Addendum 02

DOCUMENT 00 91 00

DATE: January 29, 2026

PROJECT: Tipp City Seniors New Addition
528 North Hyatt Street
Tipp City, Ohio 45371

2 FIRST FLOOR PLUMBING PLAN - UNIT A
P2.1 1/8" = 1'-0"

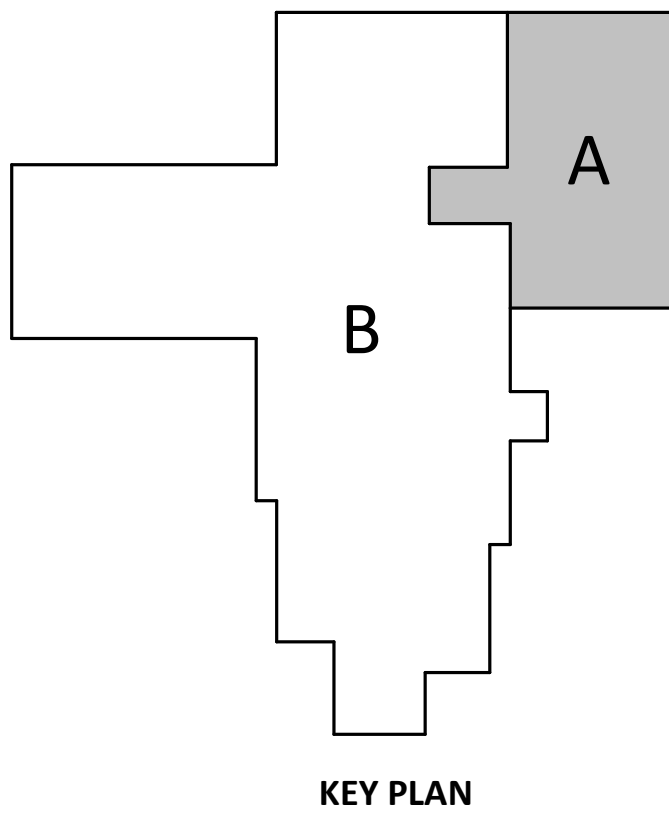
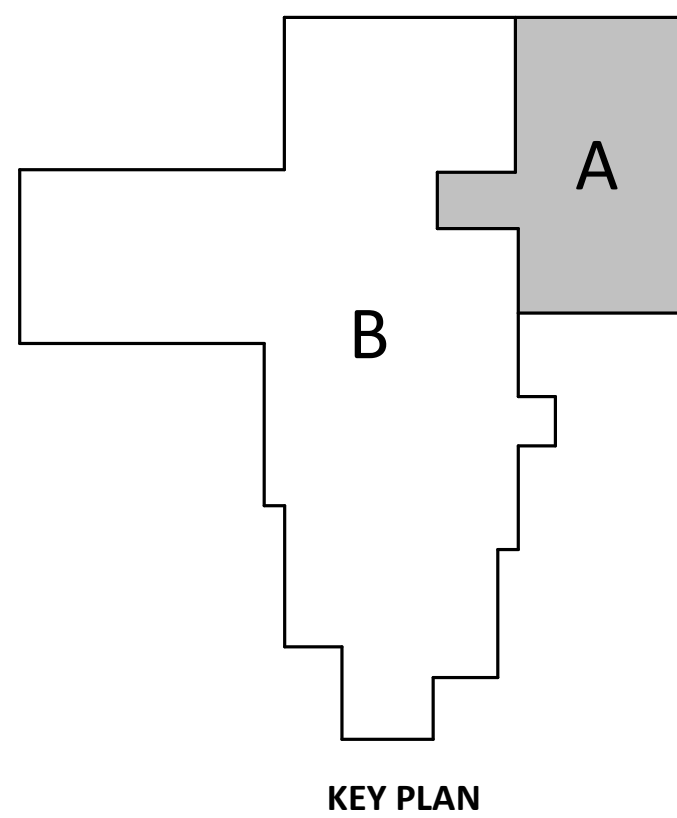
- a. Added existing furnace flue and restroom exhaust fan vent roof penetrations
6. Drawing Sheet P2.1 First Floor Plumbing Plan – Unit A:
 - a. Added existing sanitary vent roof penetration

9	APPROXIMATE LOCATION OF RESISTING SANITARY VENT THROUGH ROOF. EXTEND THROUGH THE NEW ROOF AS REQUIRED AND TERMINATE WITH NEW ROOF VENT. SEAL ROOF PENETRATION WATER TIGHT. COORDINATE PENETRATION WITH GENERAL CONTRACTOR. FIELD VERIFY PIPE SIZE, MATERIAL, AND LOCATION.
